March 11, 2024

TO : All Bidders
FROM : Bob Lavey
PROJECT : Nogales High School New Building and Aquatic Center
Project W2110000AR.41
DSA : 03-122782 / File 19-92
SUBJECT : Addendum 3

DRAWING NUMBER: **P5.1**

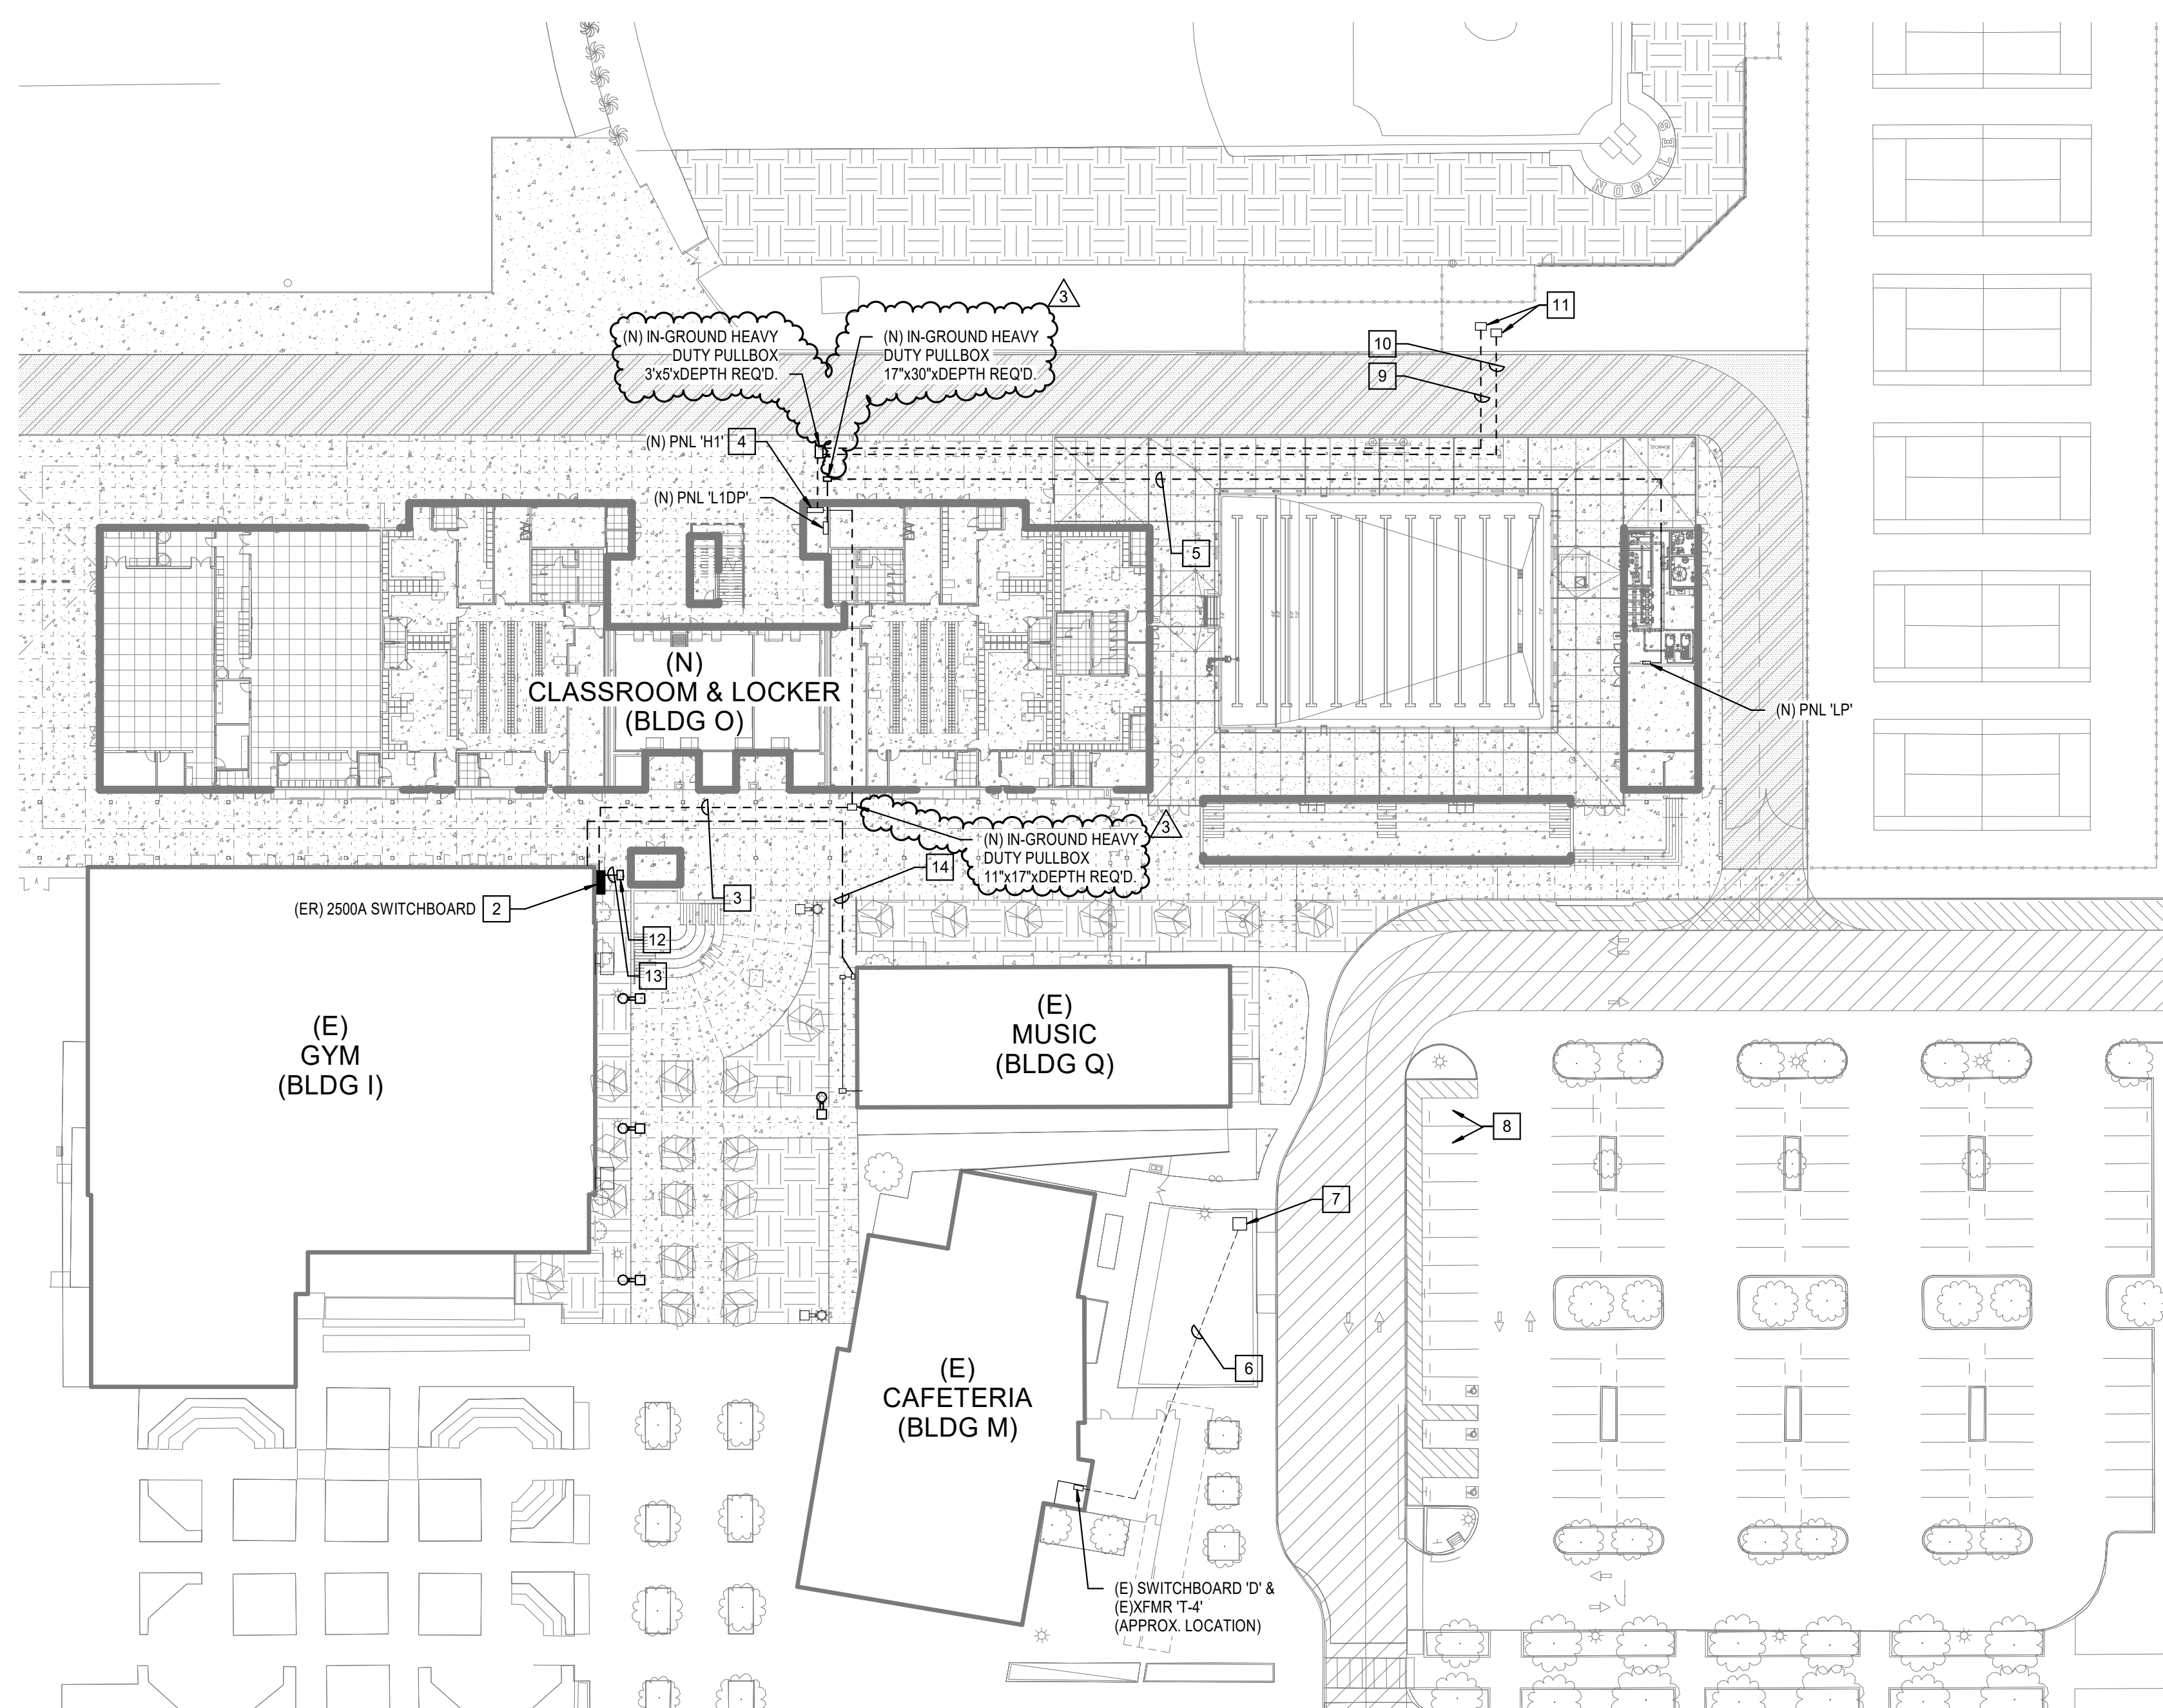
- A. Replace this drawing in its entirety with the attached Drawing P5.1.
- B. Revise Plumbing Fixture Schedule.

DRAWING NUMBER: **E1.1**

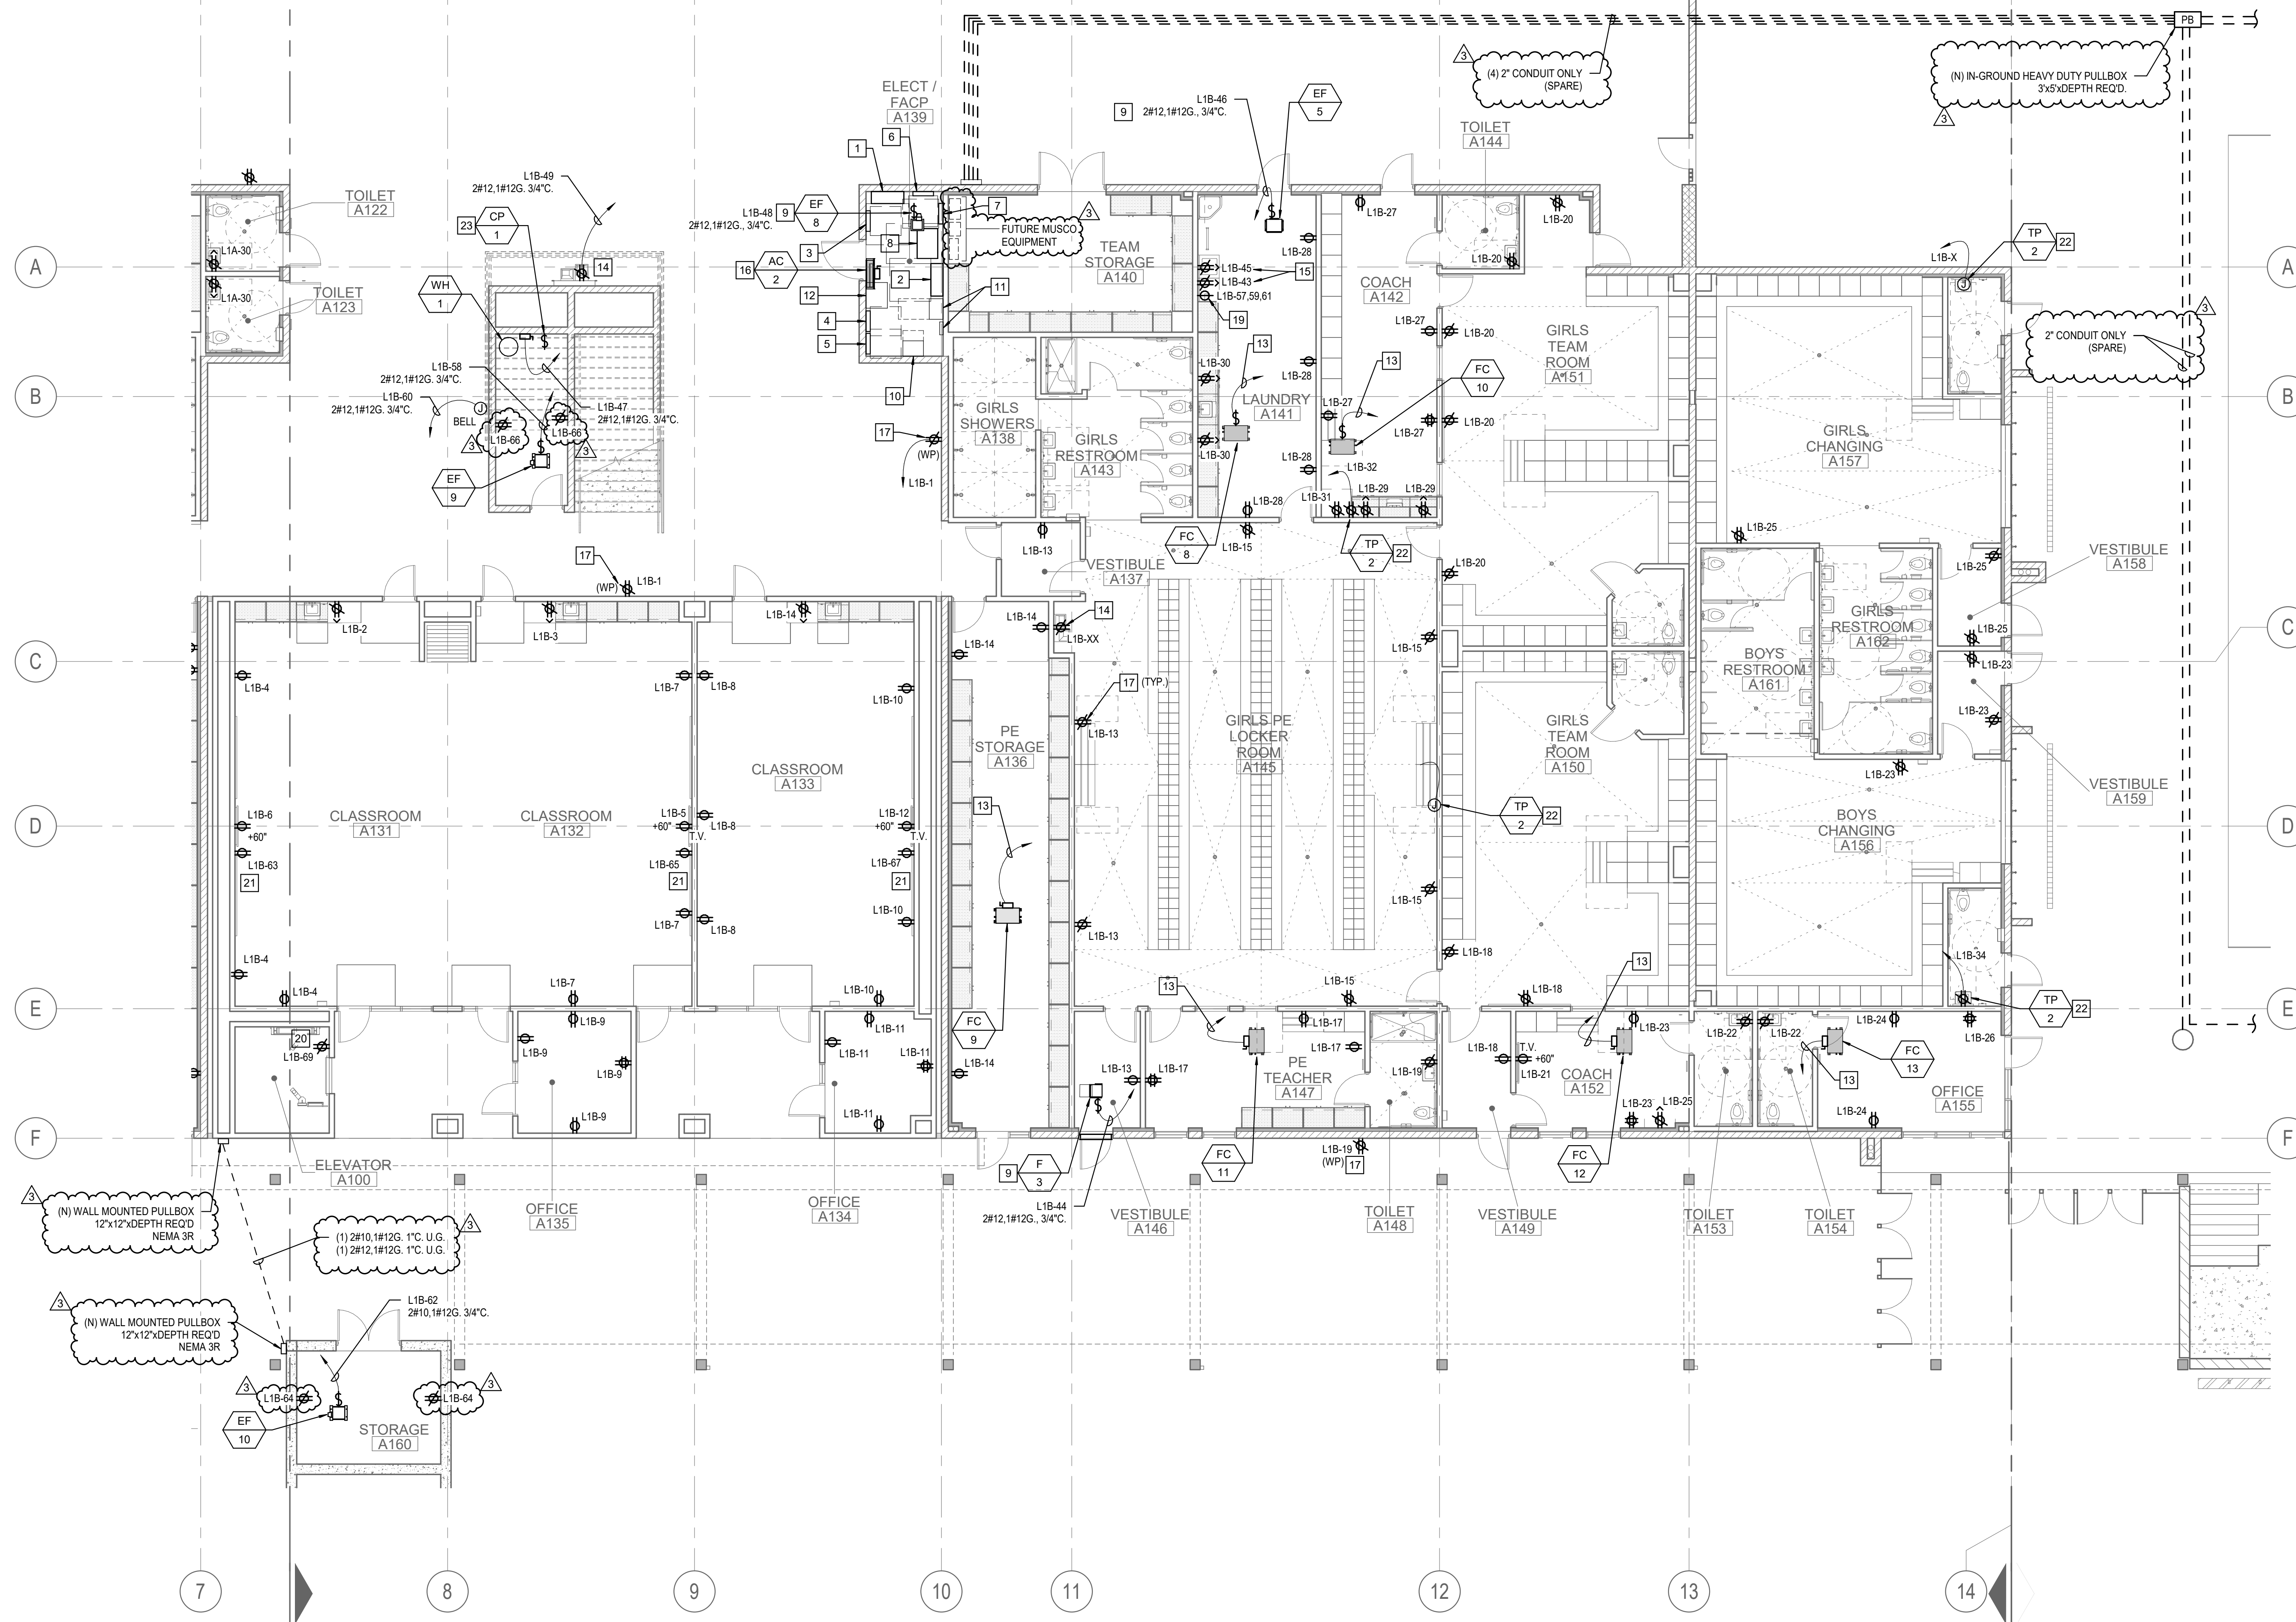
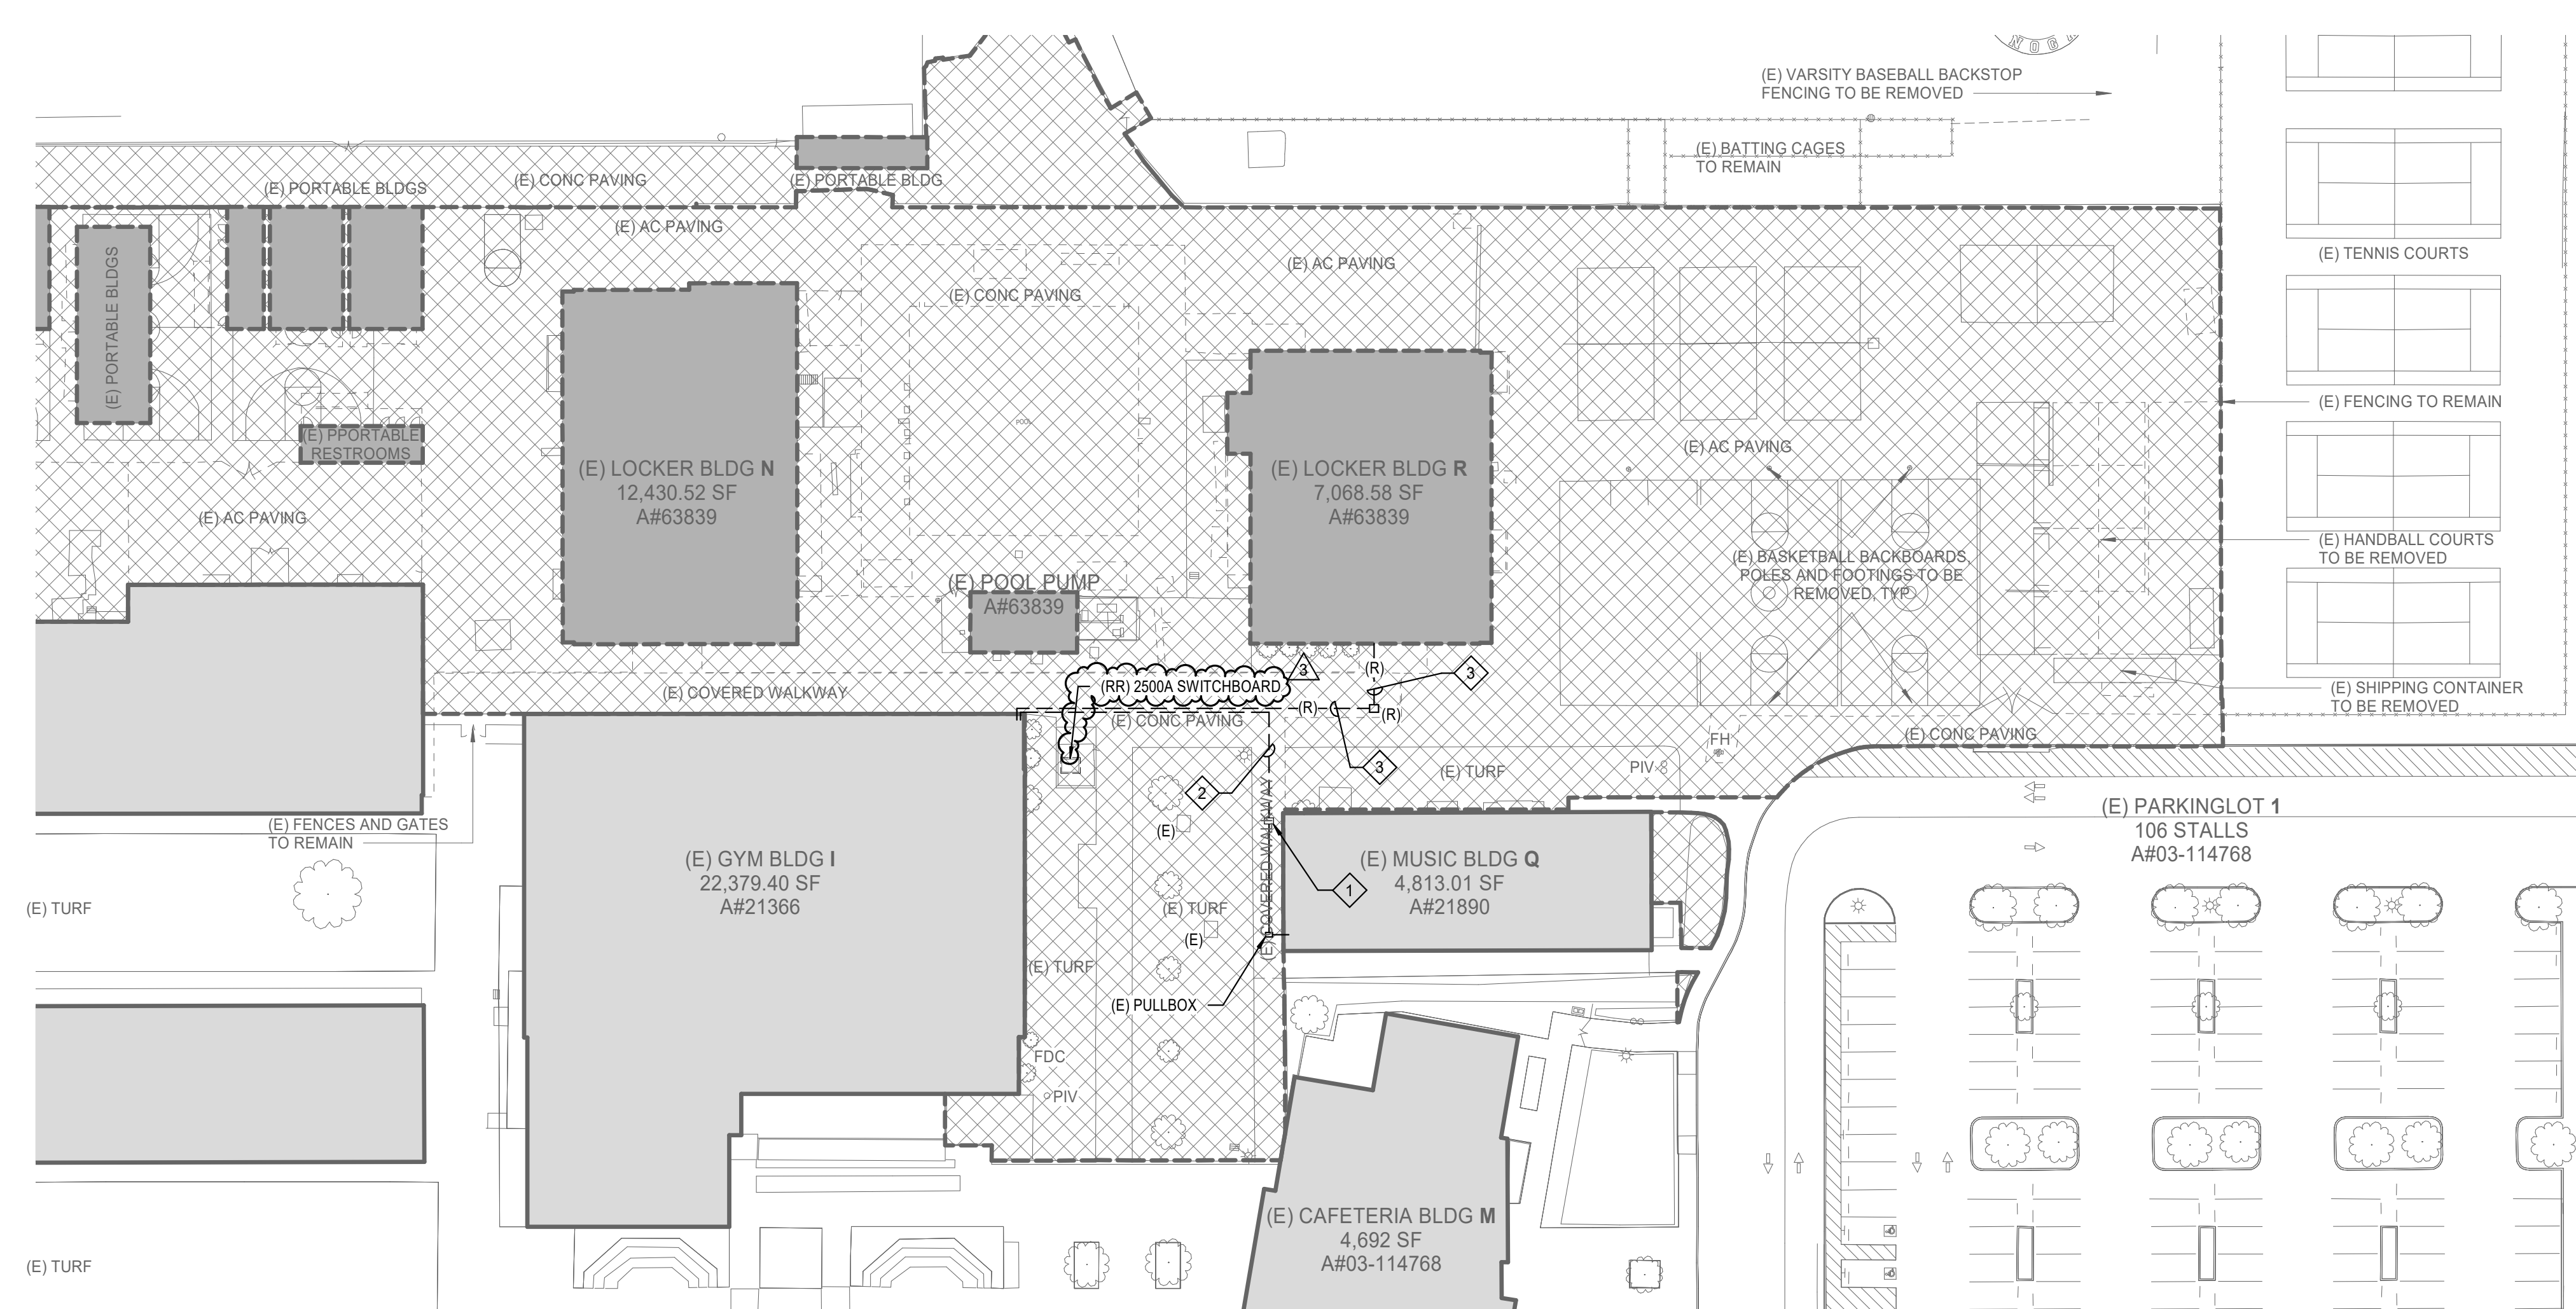
- A. Replace this drawing in its entirety with the attached Drawing E1.1.
- B. Revise to label relocated switchboard on demo plan per the attached Drawing E1.1.
- C. Added pullbox sizing per the attached Drawing E1.1.

D. Revised demo Keynote 2 per the attached Drawing E1.1.
